Access Compliance Report

Public Rights-of-Way

(Curb Ramps)

Intersection ID: 50008	Main Street: BERKELEY_PLACE_DR	Cross Street: SALERNO_DR	Location: S
ADA ID: D62B15850FA7	Ramp Type: PerpDiag	Initial Pass/Fail: Fail	Overall Compliance: No
Severity Score: 33.75			
Codes/Mitigation Info/Possible Solution		Field Measurements/Component Compliance

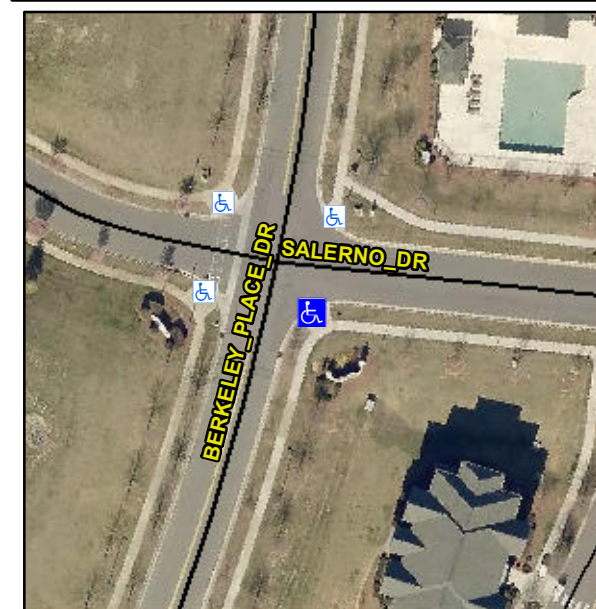
R304.5.1, R304.2.2, R304.5.3

Compliance	Description	Data	Compliance	Description	Data
N/A	Ramp Length (in)	98.0	No	Ramp Slope (%)	9.0
No	Ramp Width (in)	46.2	No	Ramp XSlope (%)	6.9
N/A	Flare Type LT	N/A	N/A	Flare Type RT	N/A
N/A	Flare Slope LT (%)	N/A	N/A	Flare Slope RT (%)	N/A
N/A	Flare Traversable LT?	N/A	N/A	Flare Traversable RT?	N/A
N/A	Landing Length (in)	N/A	N/A	DWS Provided?	N/A
N/A	Landing Width (in)	N/A	N/A	DWS Contrast?	N/A
N/A	Landing Slope (%)	N/A	N/A	DWS Length (in)	N/A
N/A	Landing X Slope (%)	N/A	N/A	DWS Full Width?	N/A
N/A	Landing Curb? (Y/N)	N/A	N/A	DWS Offset (in)	N/A
N/A	Shared Landing?	N/A			
N/A	Gutter Ponding?	N/A	N/A	Gutter Slope (%)	N/A
N/A	Gutter Lip Ht (in)	N/A	N/A	Gutter X Slope (%)	N/A
N/A	Painted X Walk1?	No	N/A	Painted X Walk2?	No
	X Walk 1 Direction	To NE		X Walk 2 Direction	To NW
N/A	X Walk 1 Width (in)	N/A	N/A	X Walk 2 Width (in)	N/A
	X Walk 1 Slope (%)	0.4		X Walk 2 Slope (%)	7.7
	X Walk 1 X Slope (%)	6.9		X Walk 2 X Slope (%)	0.5

Remove & Replace Curb Ramp With Two New Directional Ramps or Equivalent.
